## **SECTION 01380 (Addendum #2)**

**ABERDEEN PROVING GROUND, MARYLAND  
RENOVATE BUILDING 250 WATER TREATMENT PLANT  
CONTRACT NO. 18-10**

**ABERDEEN PROVING GROUND, MARYLAND  
RENOVATE BUILDING 250 WATER TREATMENT PLANT  
CONTRACT NO. 18-10**

**Revised ATTACHMENT A-1 (Addendum #2)**

DRAWING 01-D-301

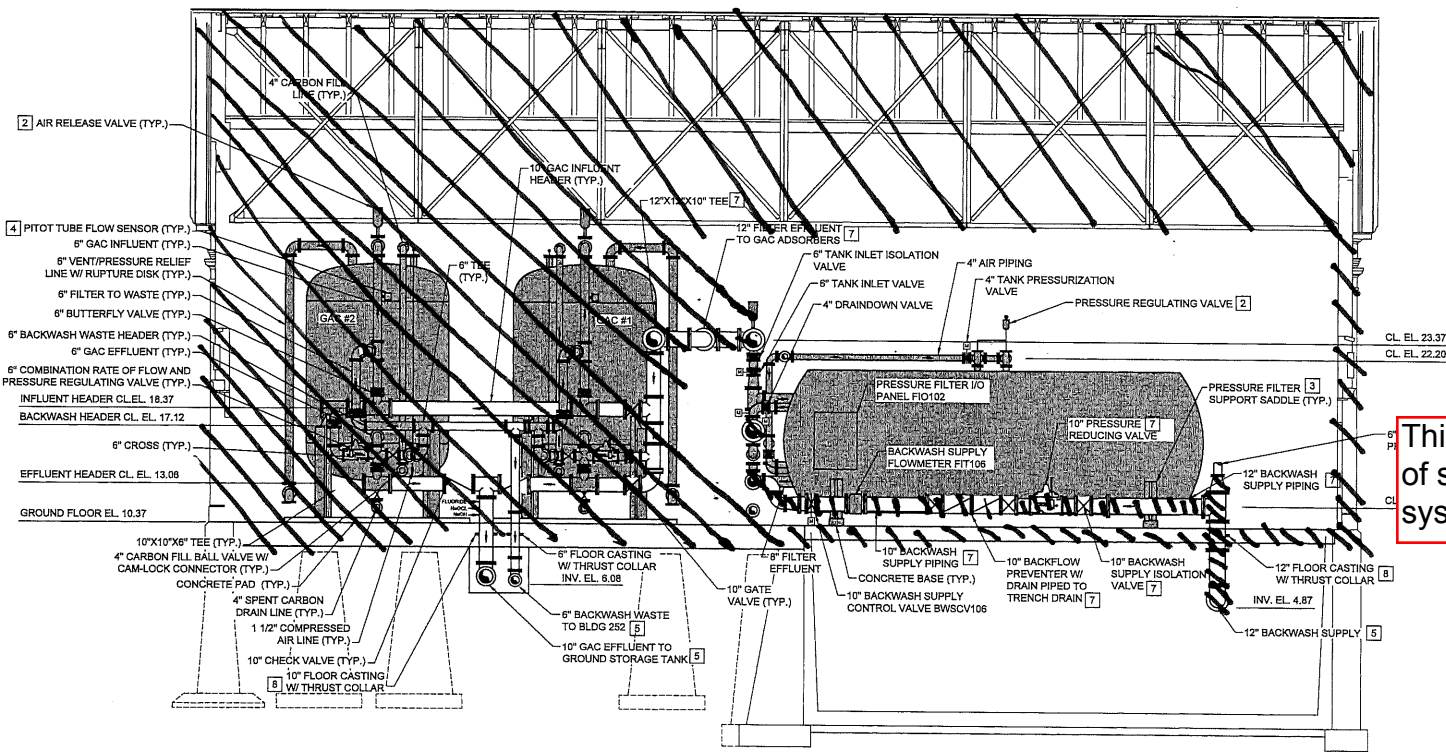
4. On plan sheet 130, the piping from the air blower to the pressure filters shows isolation valves in a location where if you closed the isolation valve on the first tank, it would cut off air to both tanks. WesTech is quoting a piping system which will alleviate this issue.
